Connah's Quay Low Carbon Power

Change Application Report

Planning Inspectorate Reference: EN010166

Document Reference: EN010166/10.1

FIGURE TITLE
 Location of Contractors' Facilities

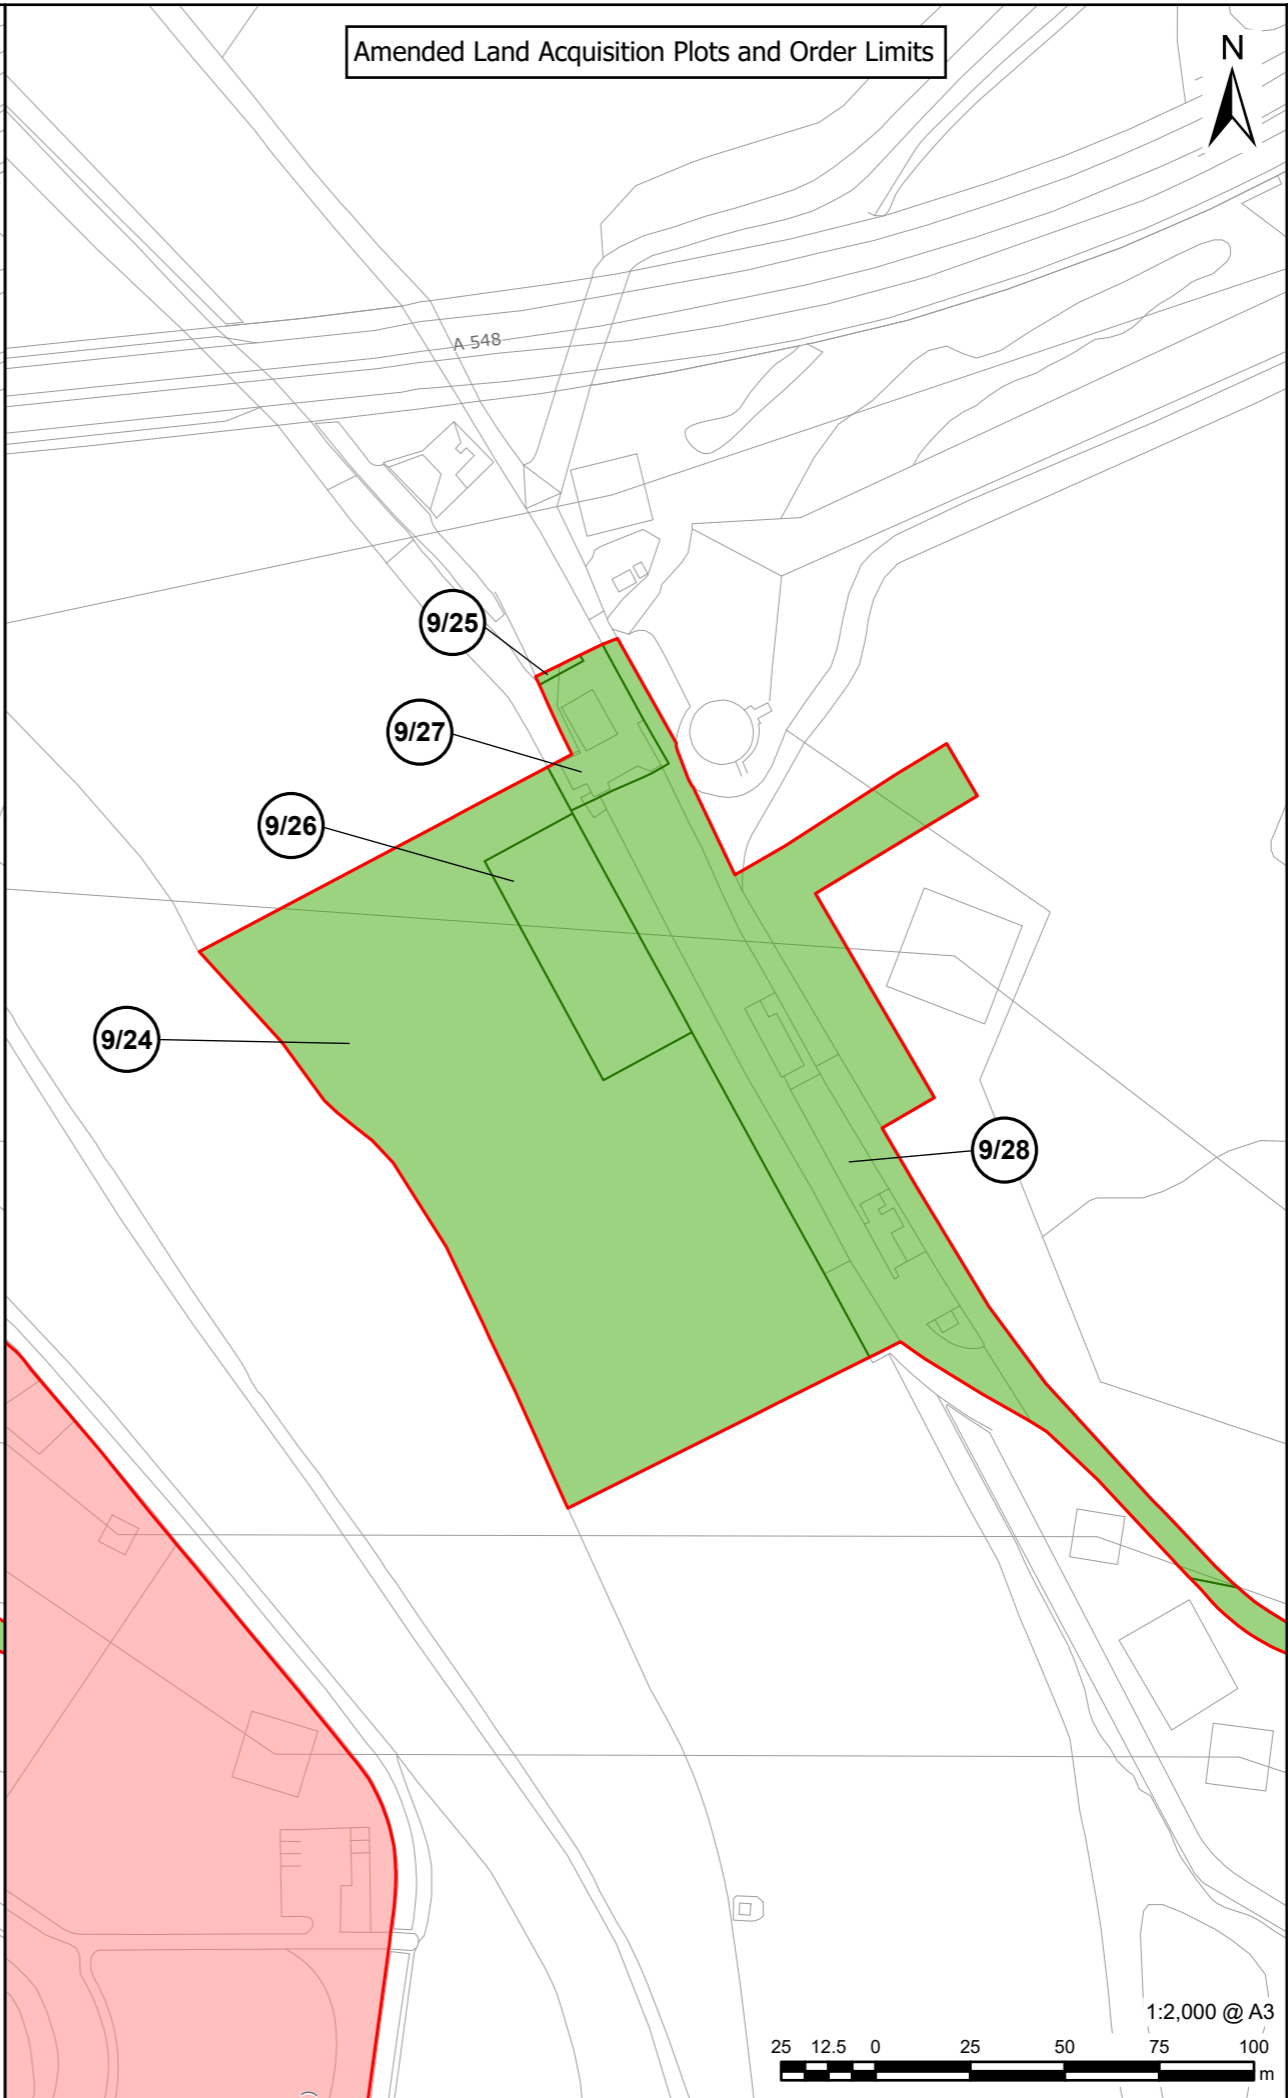
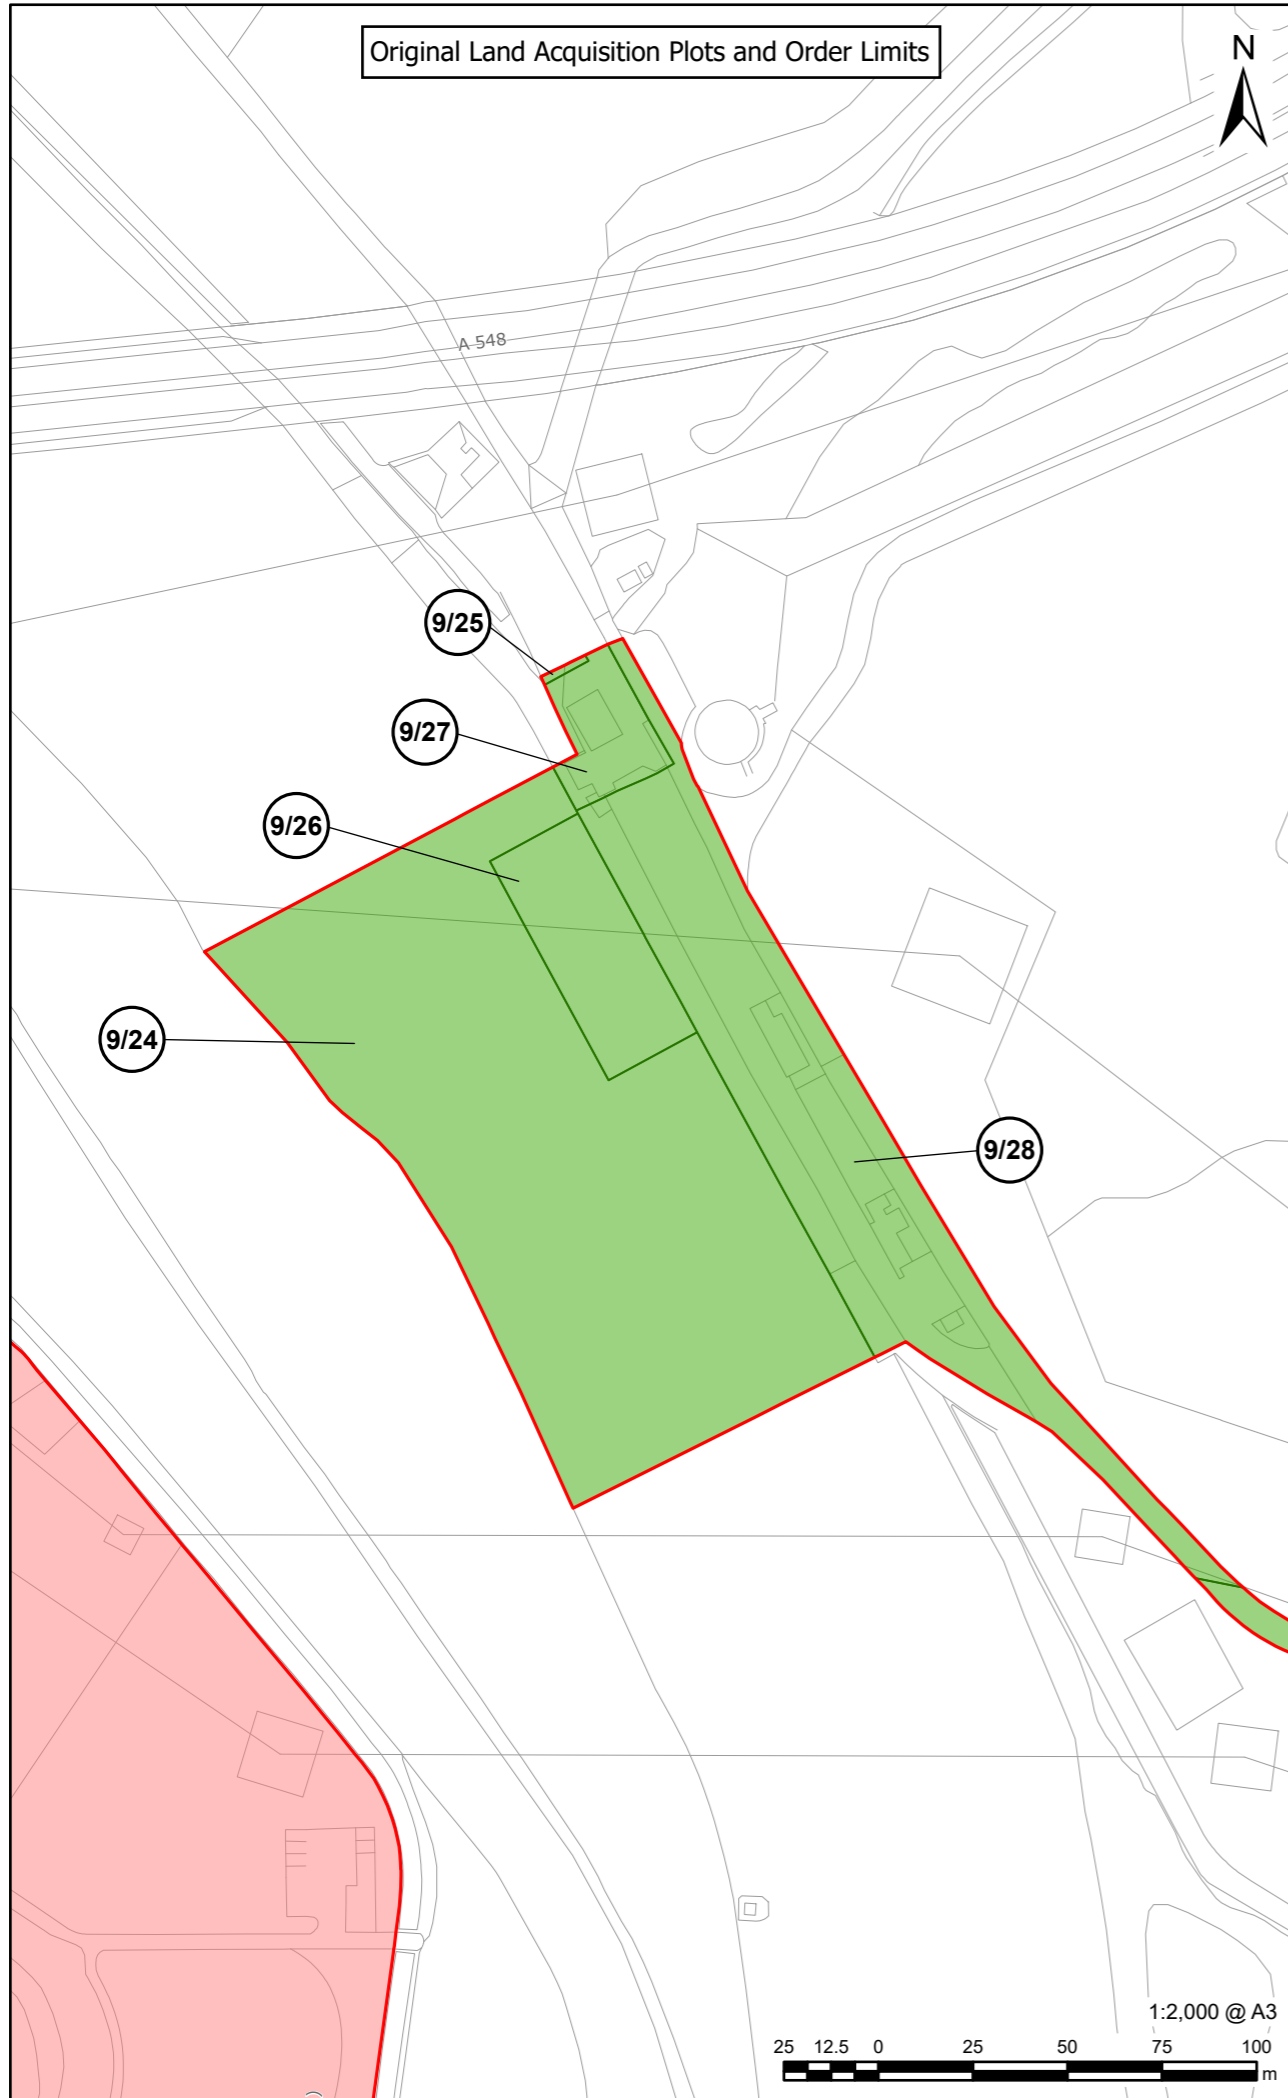
- 2.6.2 However, a further review of the available space within the existing Connah's Quay Power Station identified in the DCO Application has confirmed it cannot accommodate the required facilities in that area. Change 5, therefore, involves the relocation of the existing contractors' facilities within the Main Development Area to an alternative location to ensure there is adequate provision of facilities associated with the existing Connah's Quay Power Station. The newly proposed land is the only practical location within the Order limits that satisfies the operational and access requirements of the existing Connah's Quay Power Station.

- 2.6.3 The contractors' facilities would be laid out to make best use of the available space, and are likely to include parking areas, temporary cabins for welfare and office functions, accommodated in a mix of temporary modular structures depending on contractor requirements. Space would be allowed to account for additional facilities which would be required to support the planned outages at the existing Connah's Quay Power Station.
